**NOTICE OF ADDENDUM
ADDENDUM 1
CONTRACT NO. 8506, PROJECT NO. 10225
ANDERSON STREET RESURFACING ASSESSEMENT DISTRICT - 2020**

10225	MADISON, WI	8506
UTILITY PLAN & PROFILE		
ANDERSON STREET RESURFACING ASSESSMENT DISTRICT-2020		
M:\DESIGN\Projects\10225\CAD\Storm\10225STM-Layouts.dwg

10225		
U-1

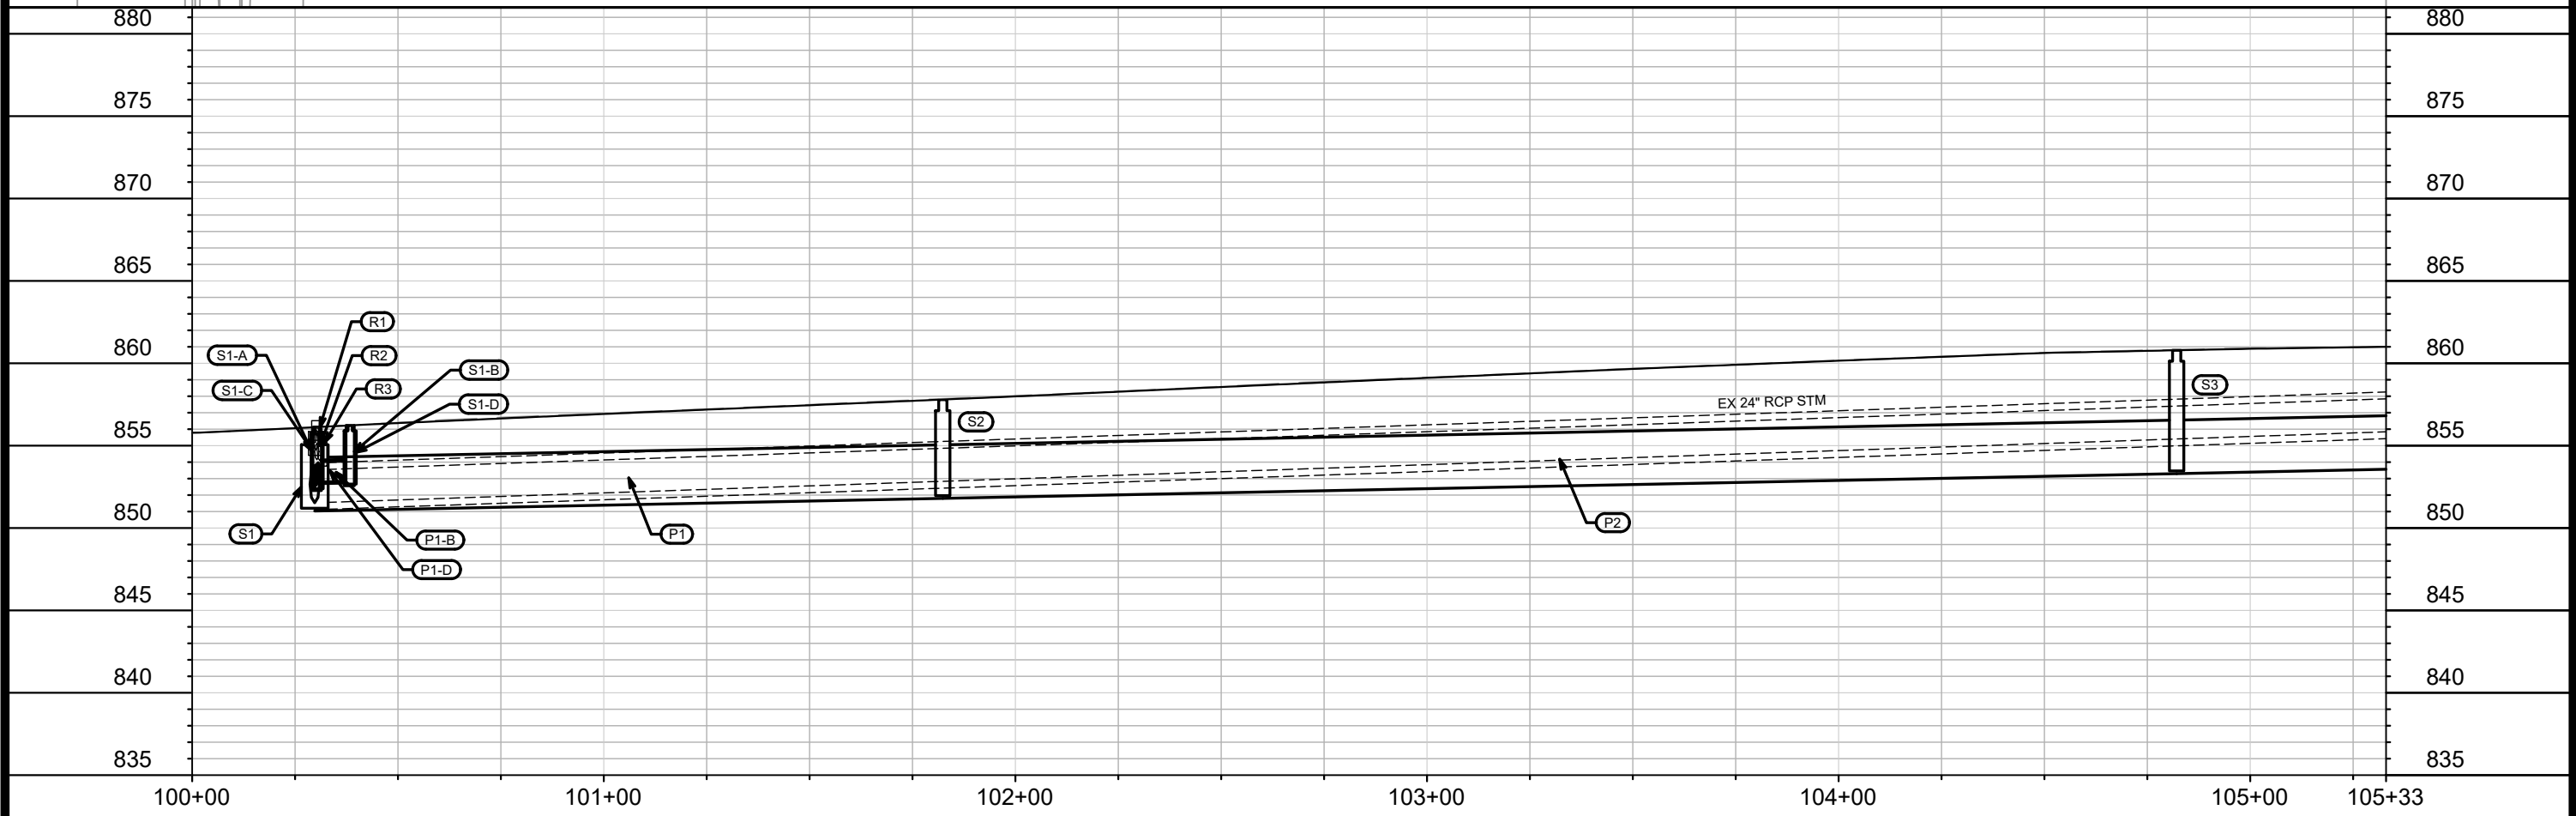
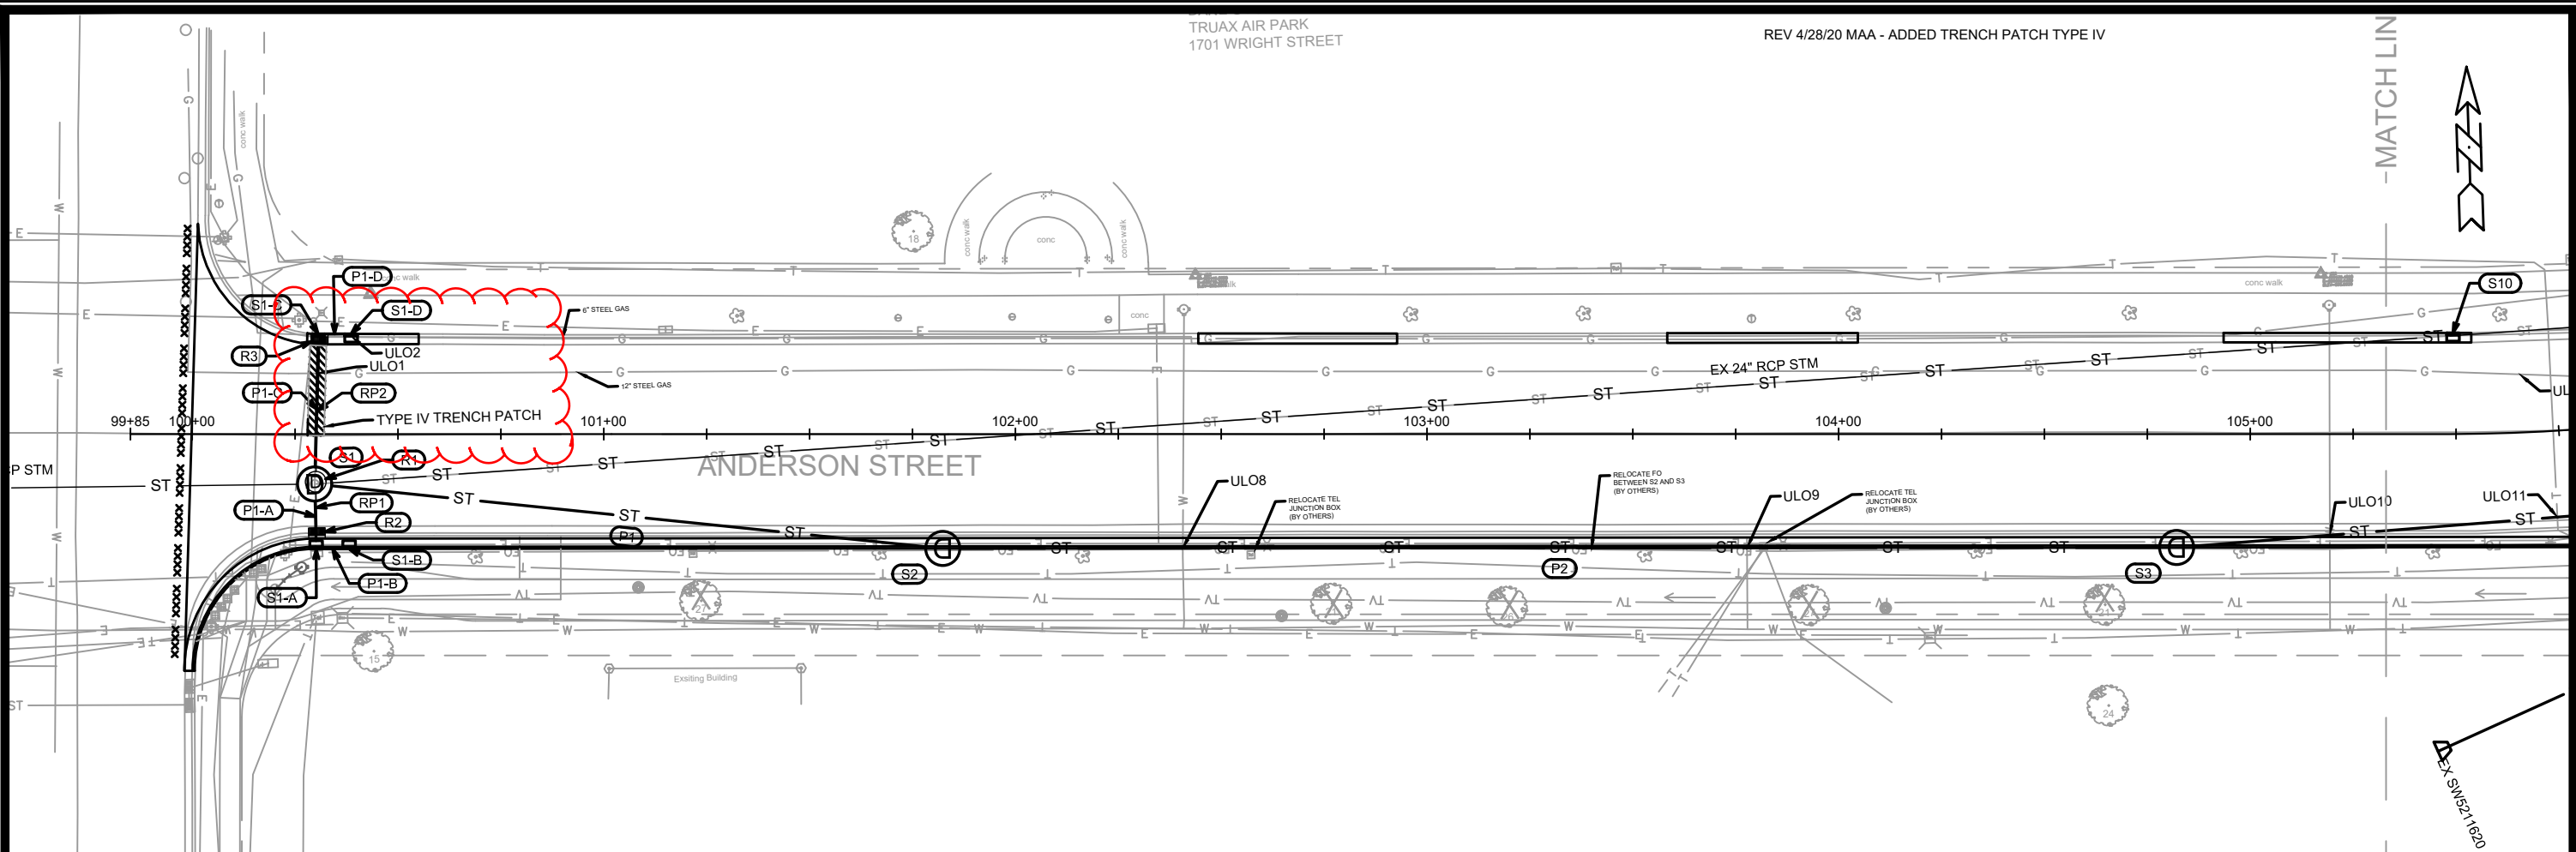
Sheet U-1 is being revised to include bid item 50227 - Utility Trench Patch Type IV to replace the disturbed pavement base course when installing storm sewer pipe P1-C. Sheet U-2 is being revised to show new location of storm sewer structure S-9. Sheet U-3 is being revised to display different lineweights, no changes to the design or quantities were made. U-4 is being replaced to reflect changes made to the storm sewer design.

REV 4/28/20 MAA - ADDED TRENCH PATCH TYPE IV

10225
 U-2

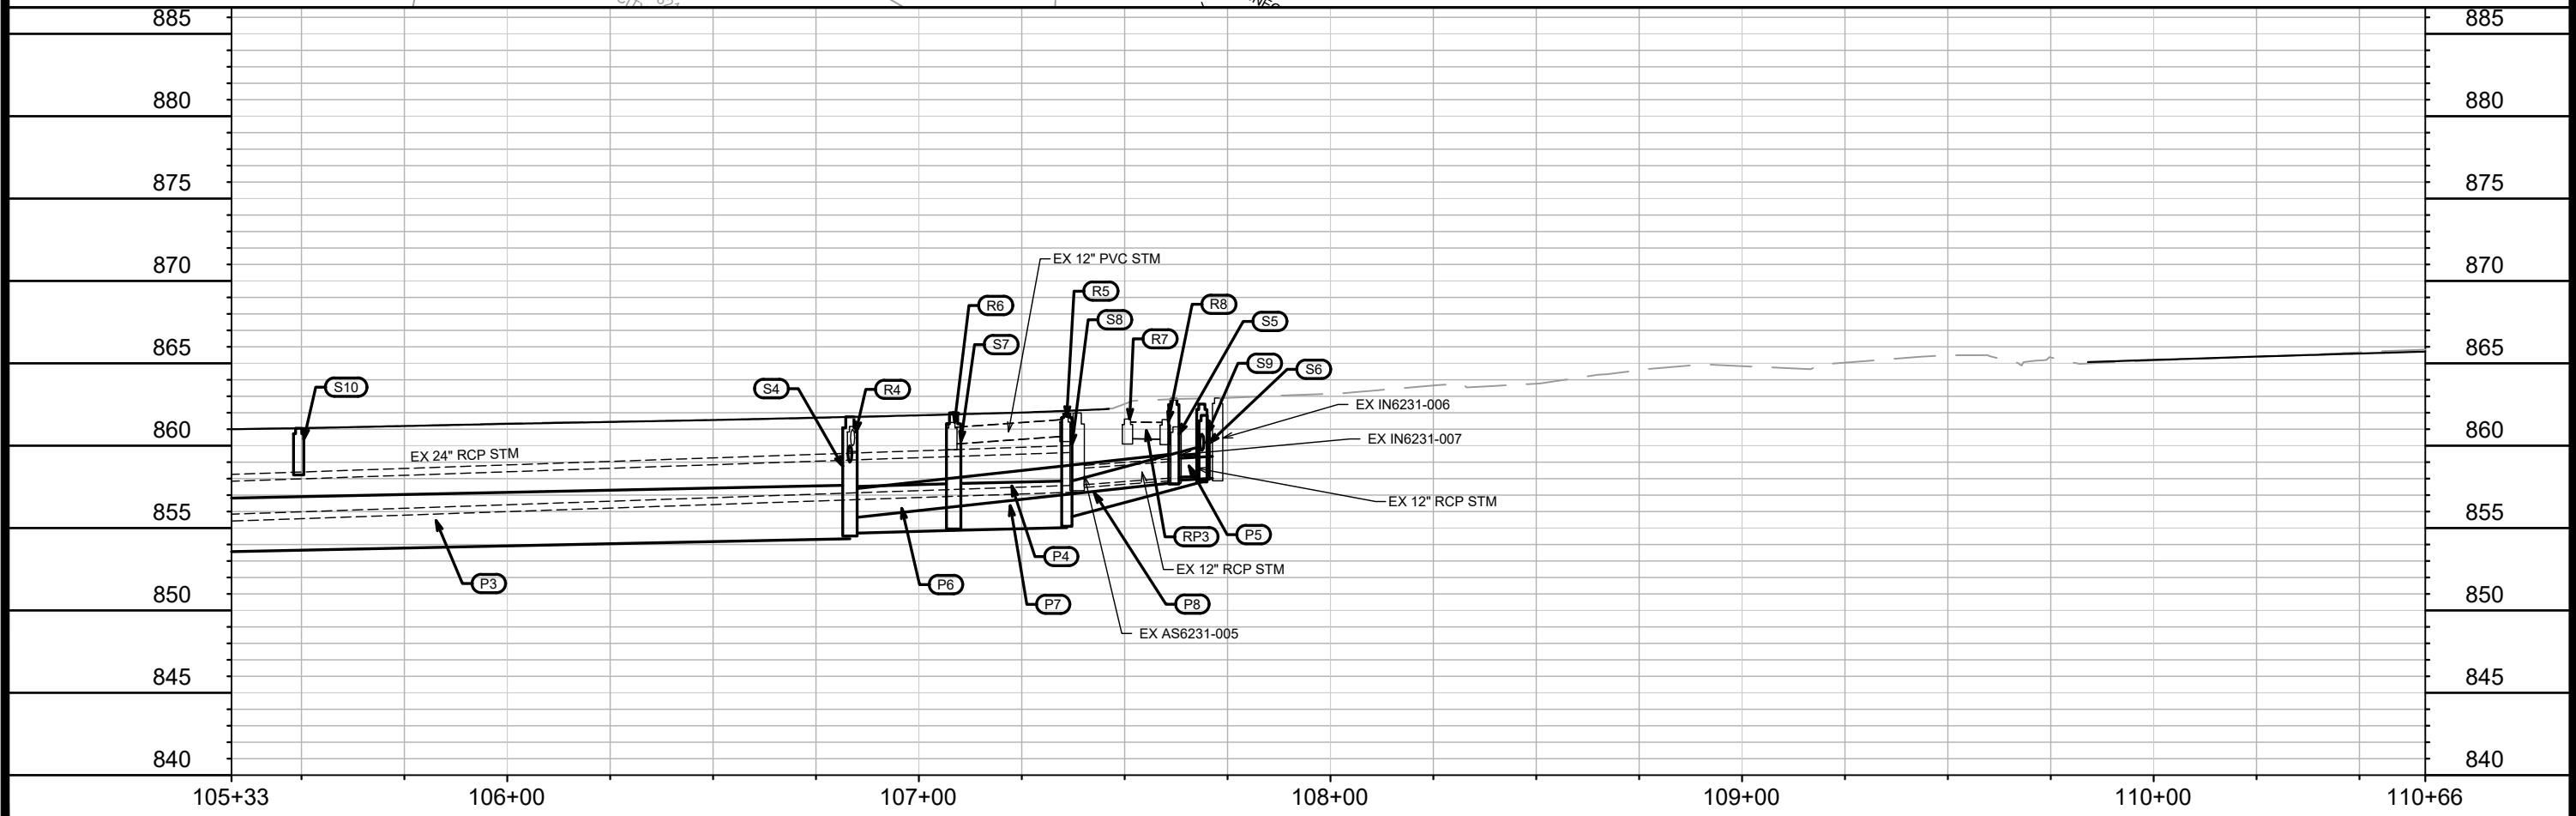
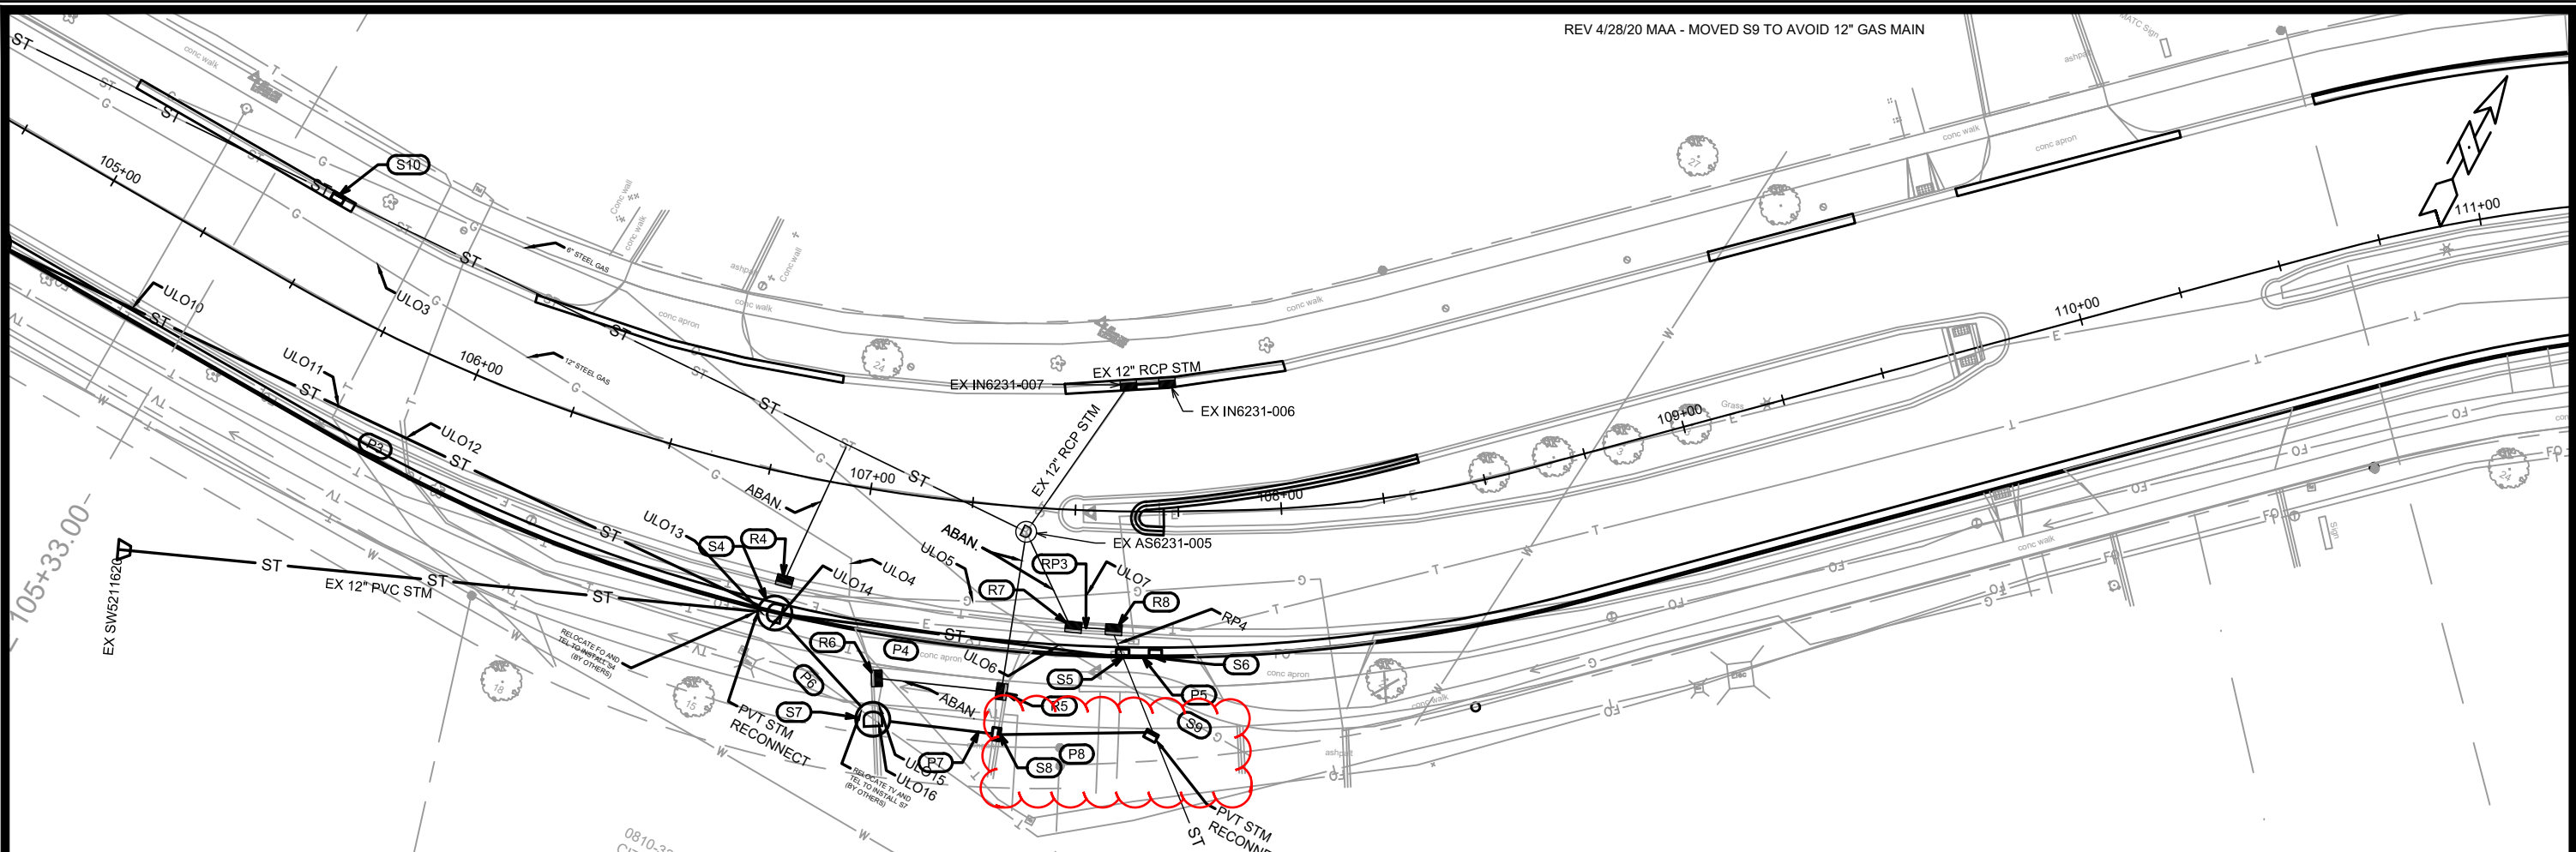
REV 4/28/20 MAA - MOVED S9 TO AVOID 12" GAS MAIN
